UNITED STATES PATENT AND TRADEMARK OFFICE

APPLICATION NO.	FILING DATE	FIRST NAMED INVENTOR	ATTORNEY DOCKET NO.	CONFIRMATION NO.
10/599,219	02/05/2007	Maurice Granger	1759,232	5939

Office Action Summary

DETAILED ACTION

Fig. 4

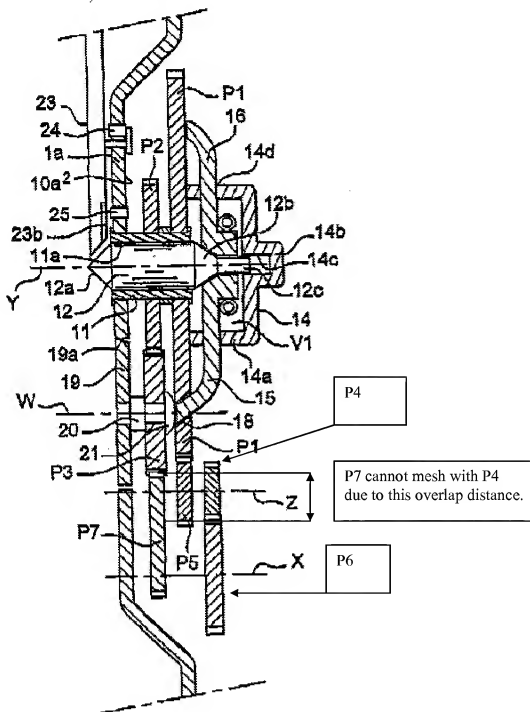
2. The Applicant is advised to provide denotations for all the pinions in Figs. 4 and 5 so that one skilled in the art can understand easily how the pinions interact together.
3. The Applicant is advised to show teeth of the pinion (P8) in Fig. 9.
4. The drawings are objected to under 37 CFR 1.83(a). The drawings must show every feature of the invention specified in the claims. Therefore, the angular spacing α must be shown or the feature(s) canceled from the claim(s). No new matter should be entered.

6. The Specification is objected to under 37 CFR 1.71 for the following reasons:
 - Line 38, page 11 calls for the pinion (P7) meshing with the pinion (P4). It is unclear how it can happen. Due to fact that the center of rotation of the pinion (P7) is off its center (See Figs. 4 and 4), the pinion (P7) can pass through the pinion (P5). However,

when the pinion (P7) aligns with the pinion (P4), the pinion (P7) cannot mesh with the pinion (P4) because the length of the pinion (P7) is greater than the distance between a first point on a tooth of the pinion (P7) and a second point on the circumference of the pinion (P4).

- Line 38, page 11, it is unclear what mechanism moves the pinion (P7) to the pinion (P4).

-Regarding the last paragraph in page 11, it appears that the paragraph describes how to dispense a small format as shown in Fig. 4. It is unclear why the pinion (P7) is displaced to the pinion (P4) since the orientation of the pinions in Fig. 4 is necessary for dispensing a small format.

-Element 23 is called an operating lever. However, in Figs. 4 and 5, it appears that element 23 reciprocates but not pivot to be called a lever.
